West Midlands Interchange Proposed Non-Material Change Environmental Implications Report

West Midlands Rail Freight Interchange Order 2020 (as amended).

Four Ashes Limited
June 2023

Figure 3.1: Consented Road Bridges

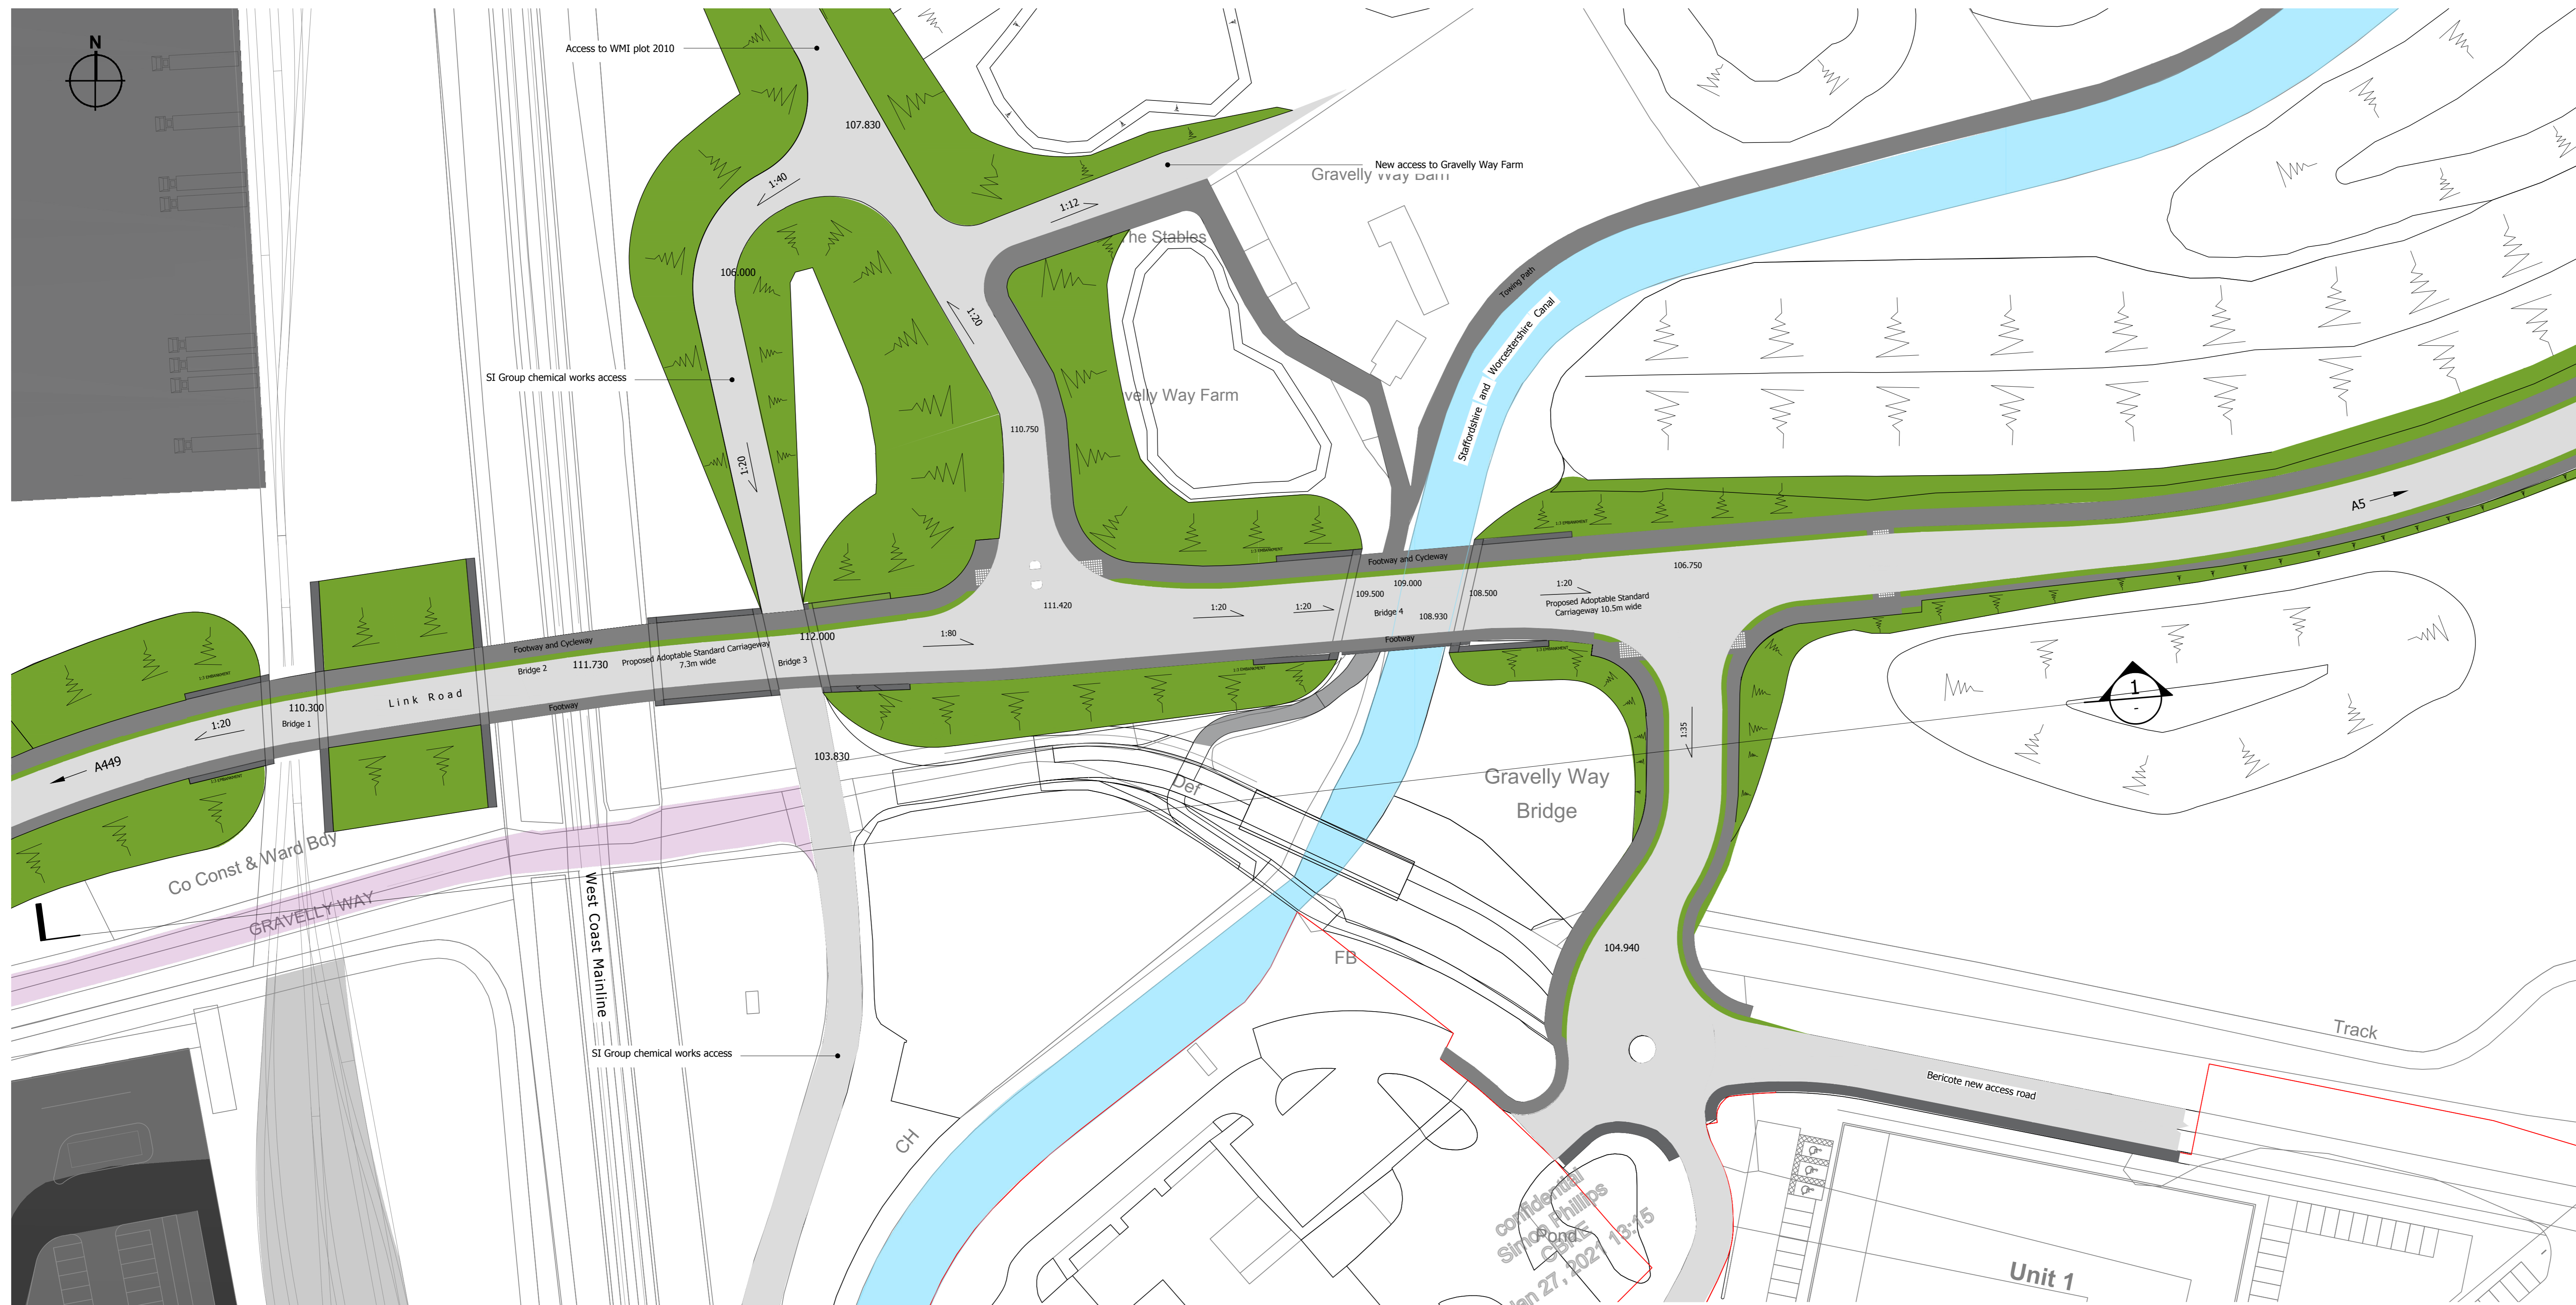
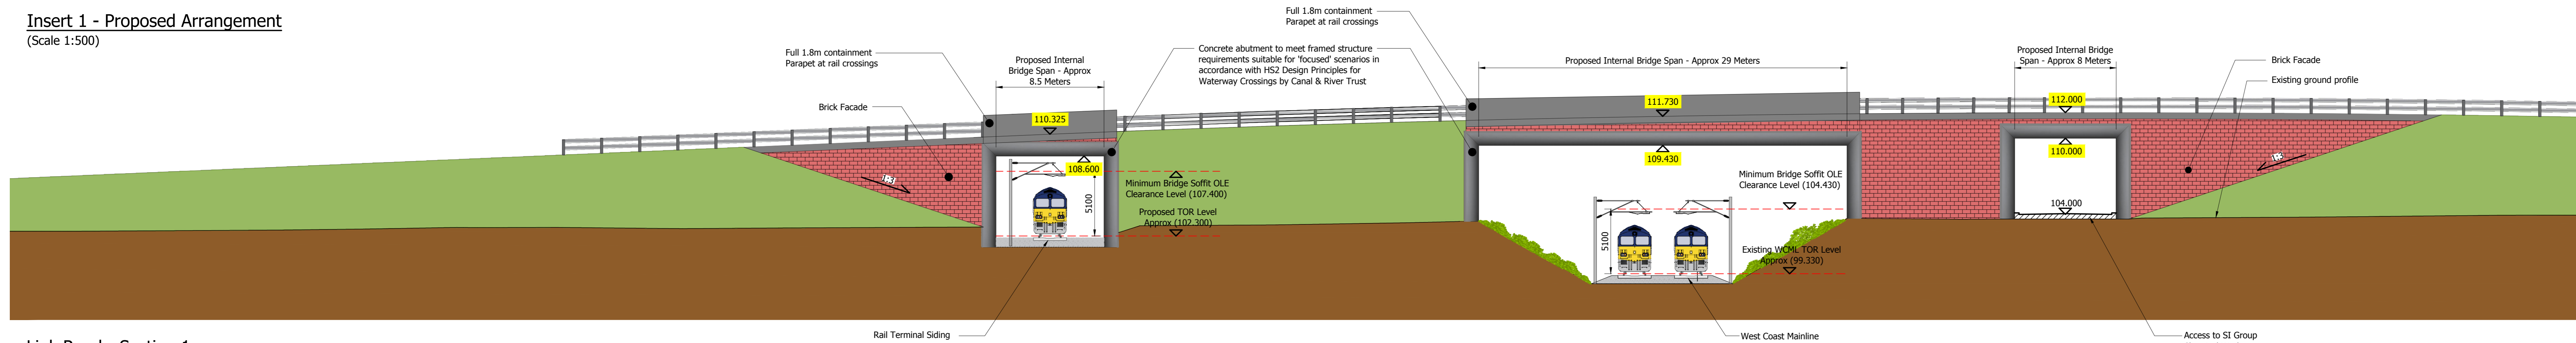
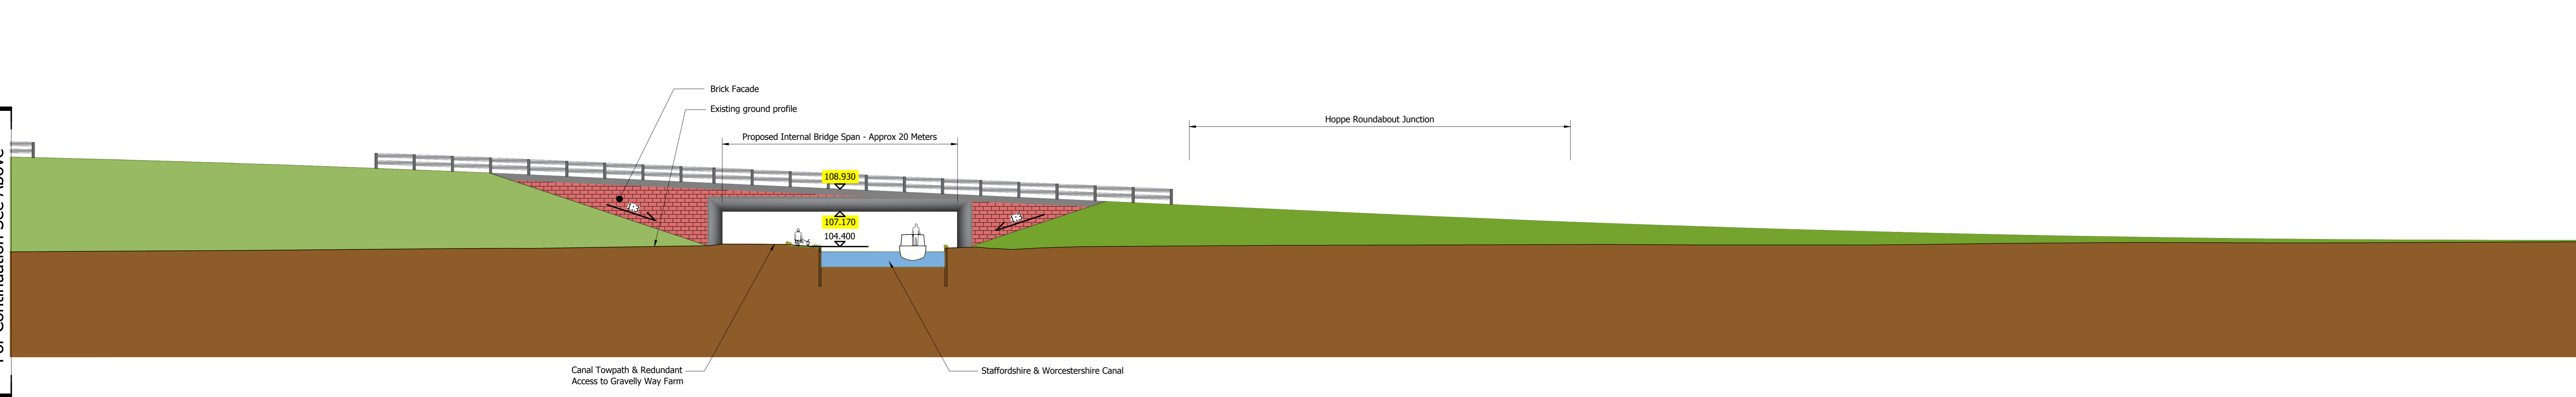
The proposed amendments seek to make the following changes to the proposed internal bridge spans identified on bridge plans, as shown by comparing **Figure 3.1** and **Figure 3.2, Appendix A**:

Figure 3.2: Proposed Road Bridges

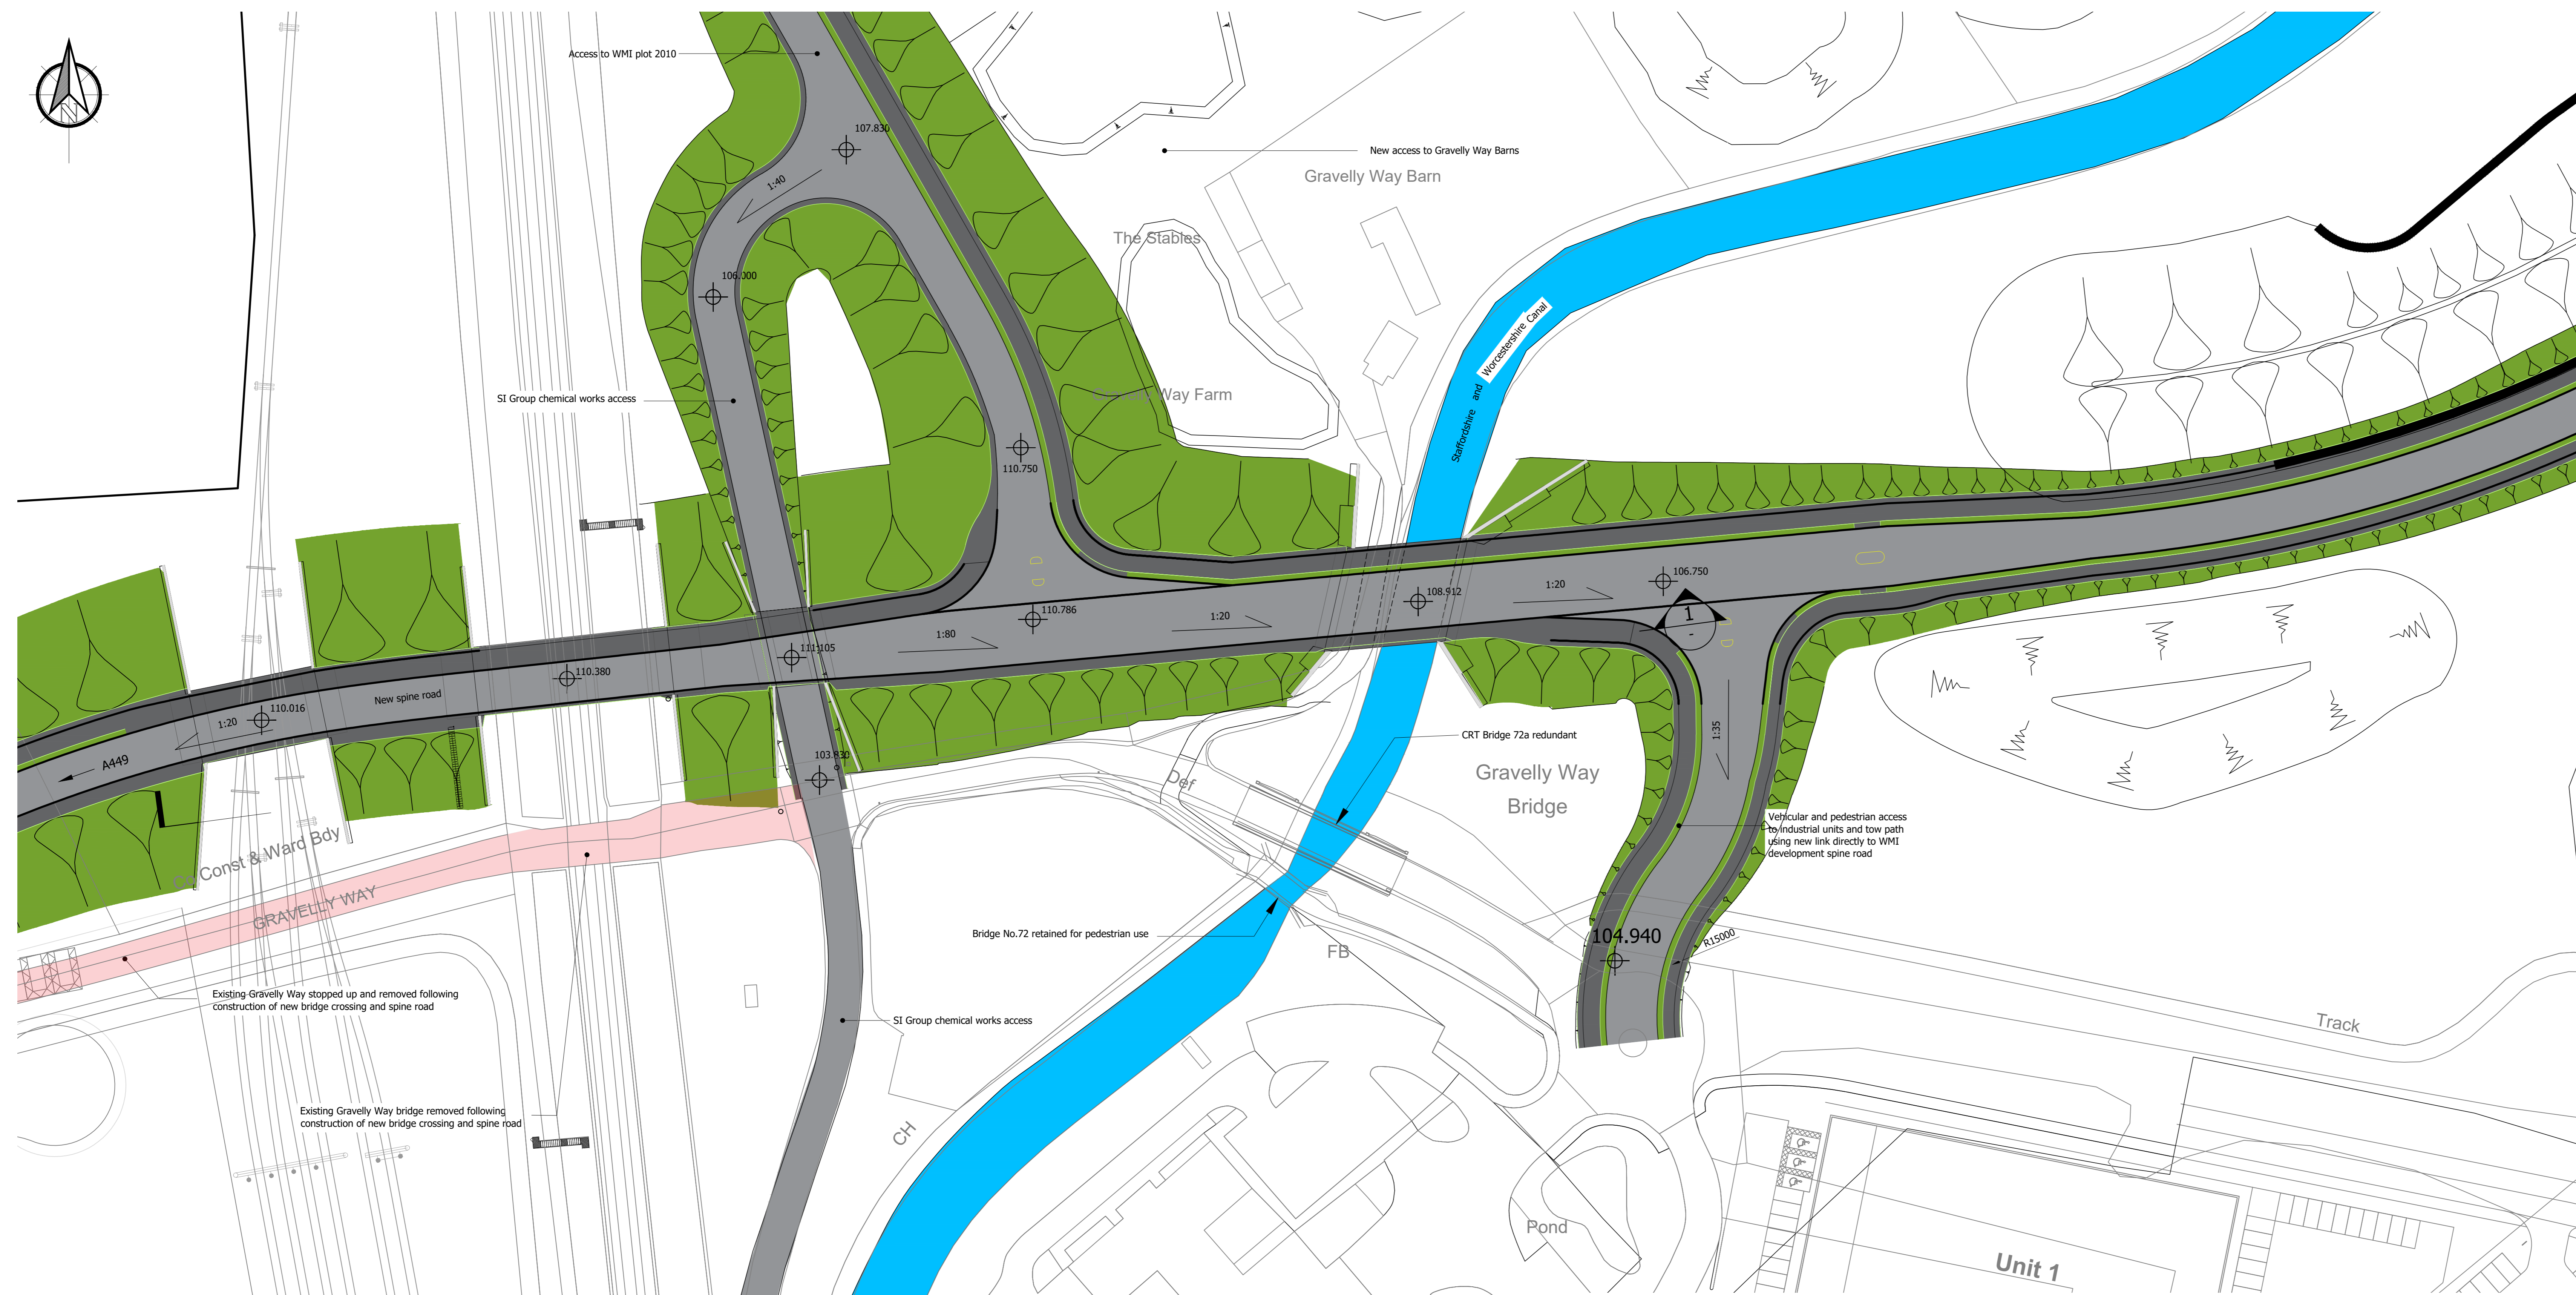
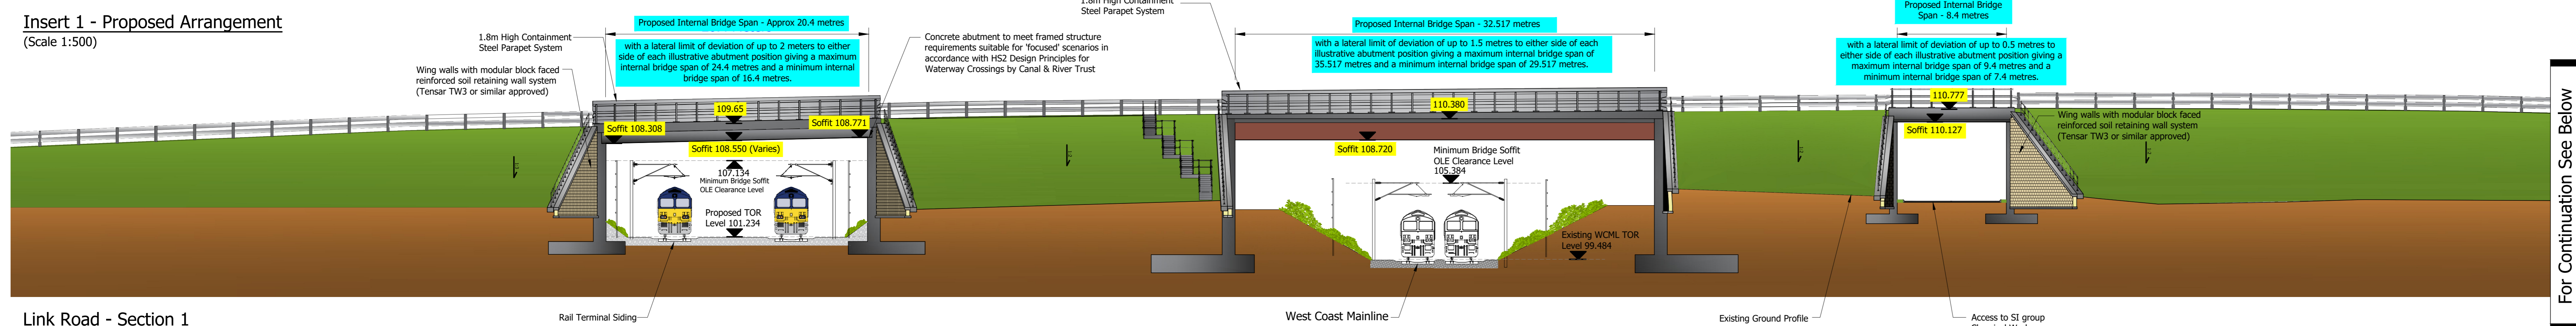
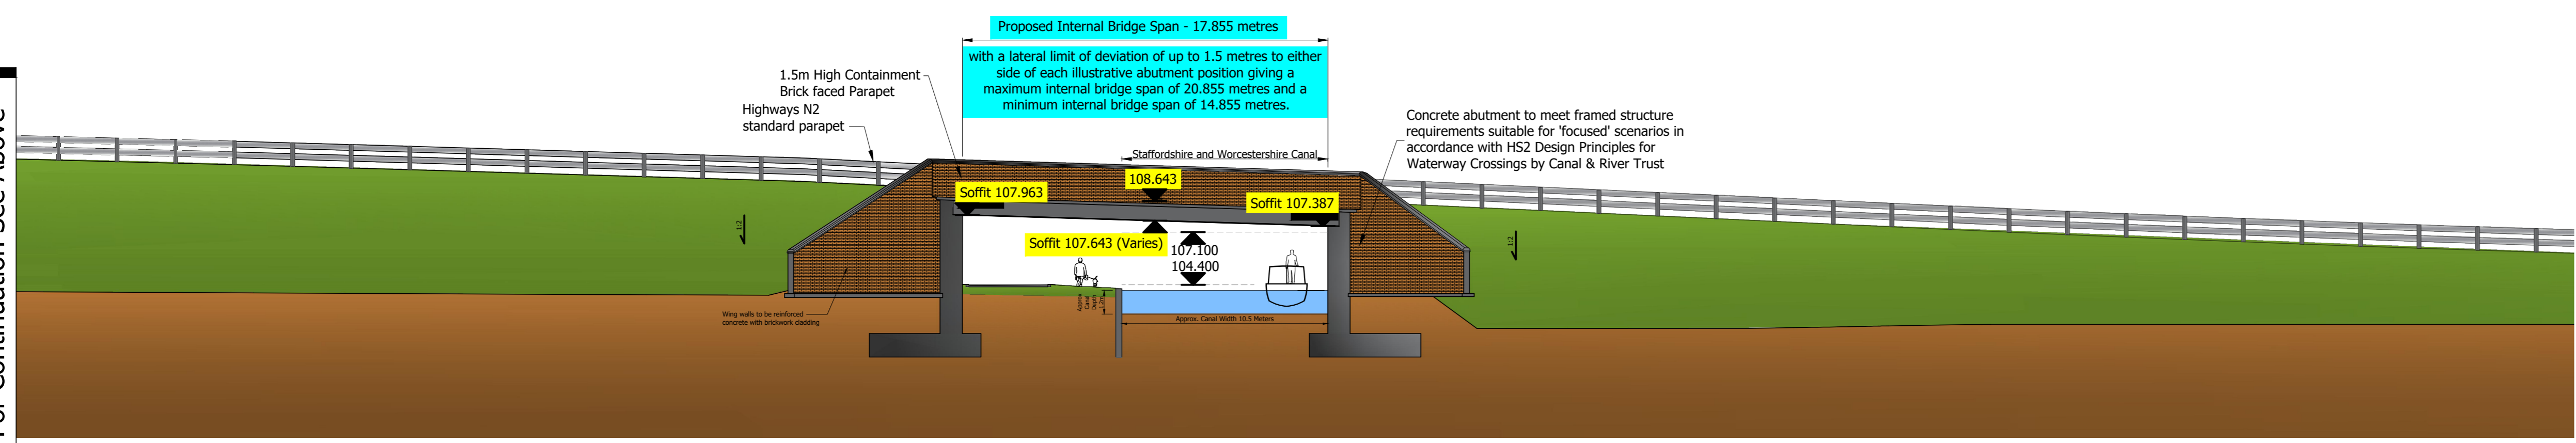
P11 Bridge 1 & 3 south verge width reduced	May 2023 LW
P10 Text colour changed to blue	April 2023 LW
P9 Bridge clear span updated.	Nov 2022 LW
Road levels updated, Wingwalls updated.	
P8 Bridge carriageway and soffit levels highlighted. Key added.	May 2018 VRL
P7 Waldeck's logo added	July 2018 NG
P6 Drawing status updated, scale bar added	July 2018 NG
P5 Drawing title & Document number amended, WMI order limits updated	12.06.18 NG
P4 Document & regulation number and drawing title amended	09.05.18 NG
P3 Notes added & amended, our OS Map updated	04.04.18 NG
P2 Title amended	06.03.18 JRB
P1 Issued for Comment	06.03.18 JRB
